HARVEST ROAD

48TH AVENUE TO 56TH AVENUE - INFRASTRUCTURE SITE PLAN

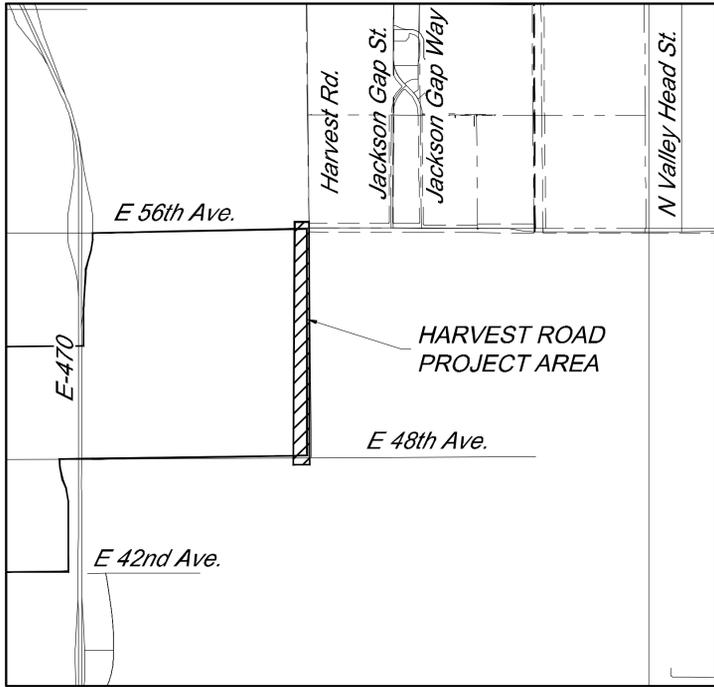
Is the ROW already dedicated?
Is there a legal description?

disturbance not needed. What is the area in the ROW?

Add Owners information.

ROW is dedicated,
reception #s are shown on plans
20060524000533770
20060515000496490
2006000505740
2023000009755

Table has been revised

Owner information shown on cover

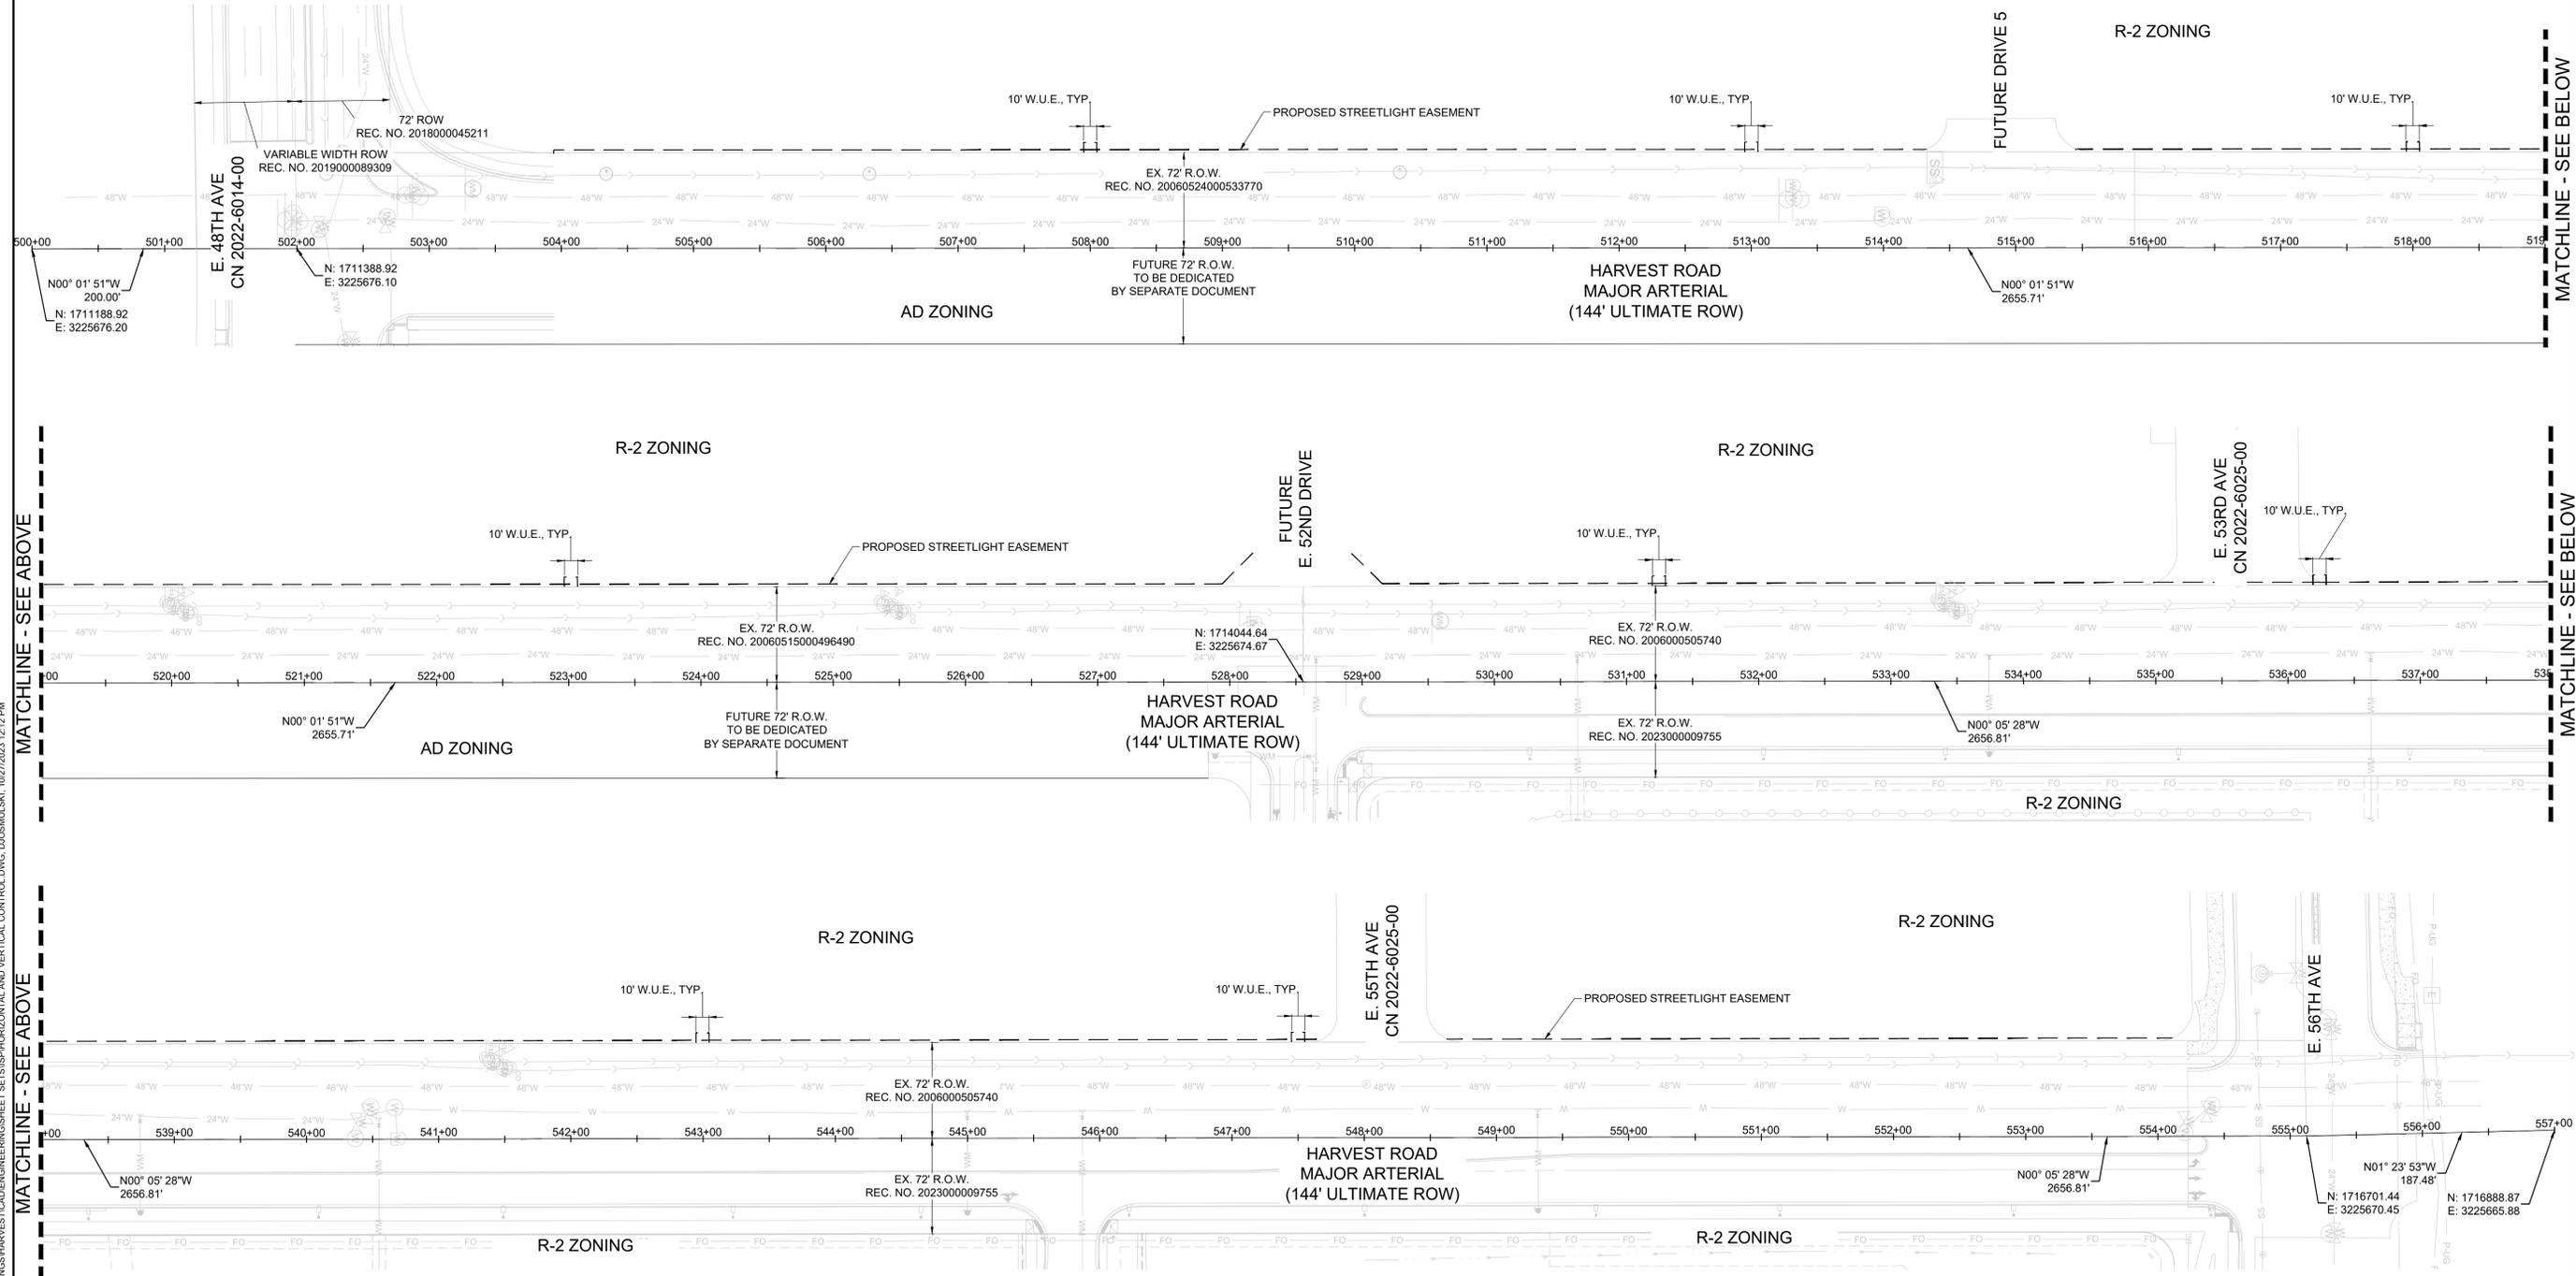
repeat comment. Increase font size.
for future reference, all site plans and ISPs must be a min. of 1"=40'

previous comment not appropriately addressed.
show entire eastern half of Harvest Road, including opposing accesses. Applicant indicated this submittal is for the ultimate condition therefore NB travel lanes need to be shown for Harvest Rd
Verify intersection laneage with MTIS

This location of streetlights is new with this submittal. If the lights are temporarily permitted to be behind the back of walk, an easement will be required. The final location of lights will be approved with the civil plans.

no receiving lane for through lane. future T intersection, remove lane, update intersection geometry, including signing striping

remove sign, not shown on plans, typ.

Acknowledged, future site plans will be at 1" = 40' scale.
All font sizes below min have been increased.

Per previous comment response, east half of Harvest between 48th and 52nd is future. Opposing accesses are not known at this time. Interim condition has been added between 48th and 52nd per discussions with Steve Gomez on 12/6

Light locations have not changed since the Olsson submittal. Easement linework is shown and called out on sheet 3 and area utility/grading plans. Note is included that final lighting locations will be determined with the civil plan submittal

Right turn lane striping added. Striping through intersection not added per discussions with Steve Gomez on 12/6

intersection geometry has been revised to accommodate T intersection.

Sign has been relocated

Advanced lane designation sign added

Barricade extended

Sign has been replaced

Left turn only is not applicable sign added to match above comment

SHEET NUMBER
5

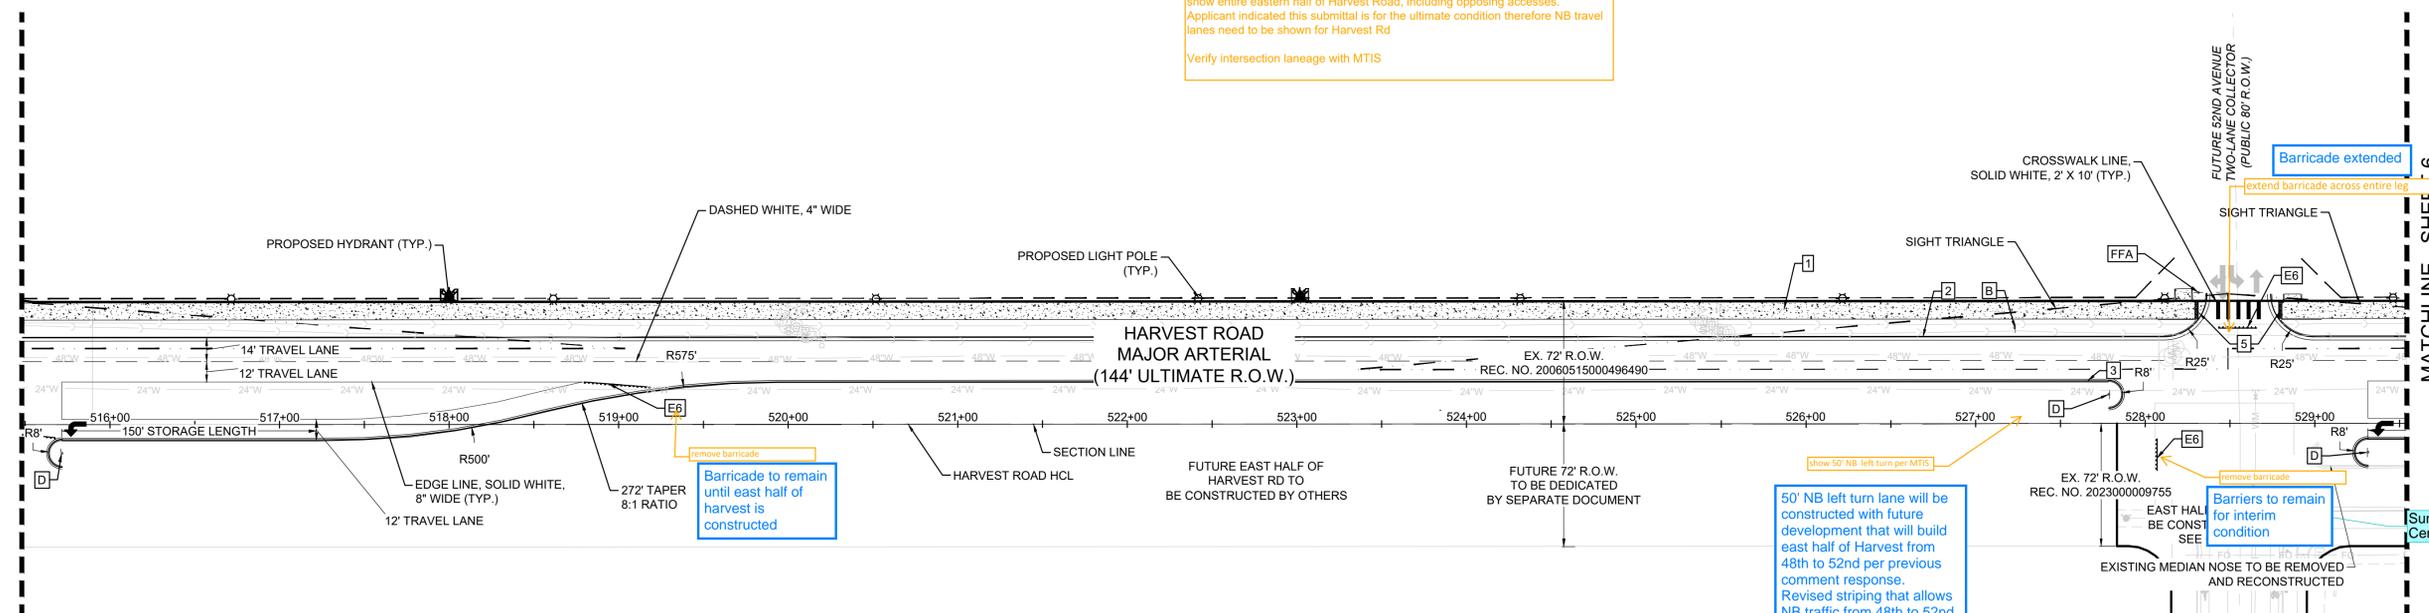
previous comment not appropriately addressed.
show entire eastern half of Harvest Road, including opposing accesses. Applicant indicated this submittal is for the ultimate condition therefore NB travel lanes need to be shown for Harvest Rd
Verify intersection laneage with MTIS

show 50' NB left turn per MTIS

Barricade extended
extend barricade across entire leg

Per previous comment response, east half of Harvest between 48th and 52nd is future. Opposing accesses are not known at this time. Interim condition has been added between 48th and 52nd per discussions with Steve Gomez on 12/6

50' NB left turn lane will be constructed with future development that will build east half of Harvest from 48th to 52nd per previous comment response. Revised striping that allows NB traffic from 48th to 52nd has been added to this plan set.

Barriers to remain for interim condition

Callout revised

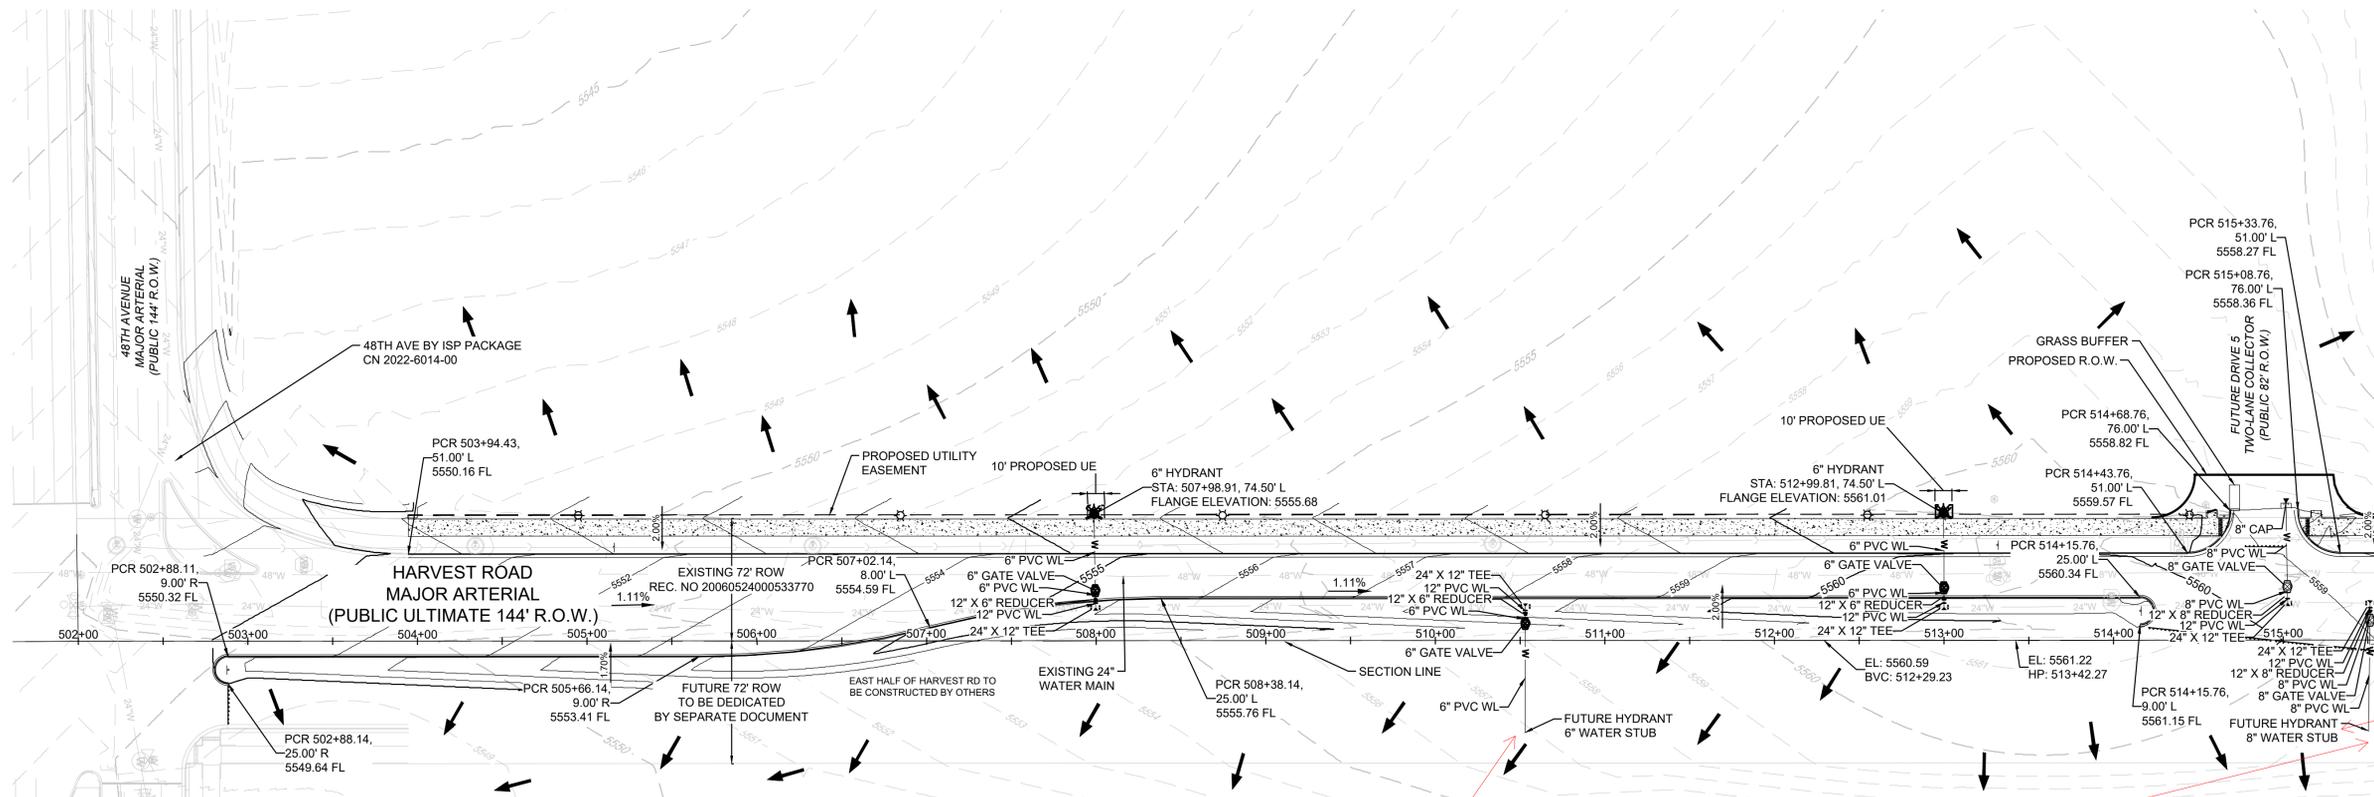
If this is only for a hydrant lateral then it would be 6-inch not 8-inch.
Line diameter updated

Utilities that are not within public ROW require easement. This also applies to future ROW that has not been dedicated yet.
Easements are to reflect the utility within them. For example an easement that contains water and sanitary is a Water and Sanitary Easement.

Easement to be added to all utilities outside of ROW
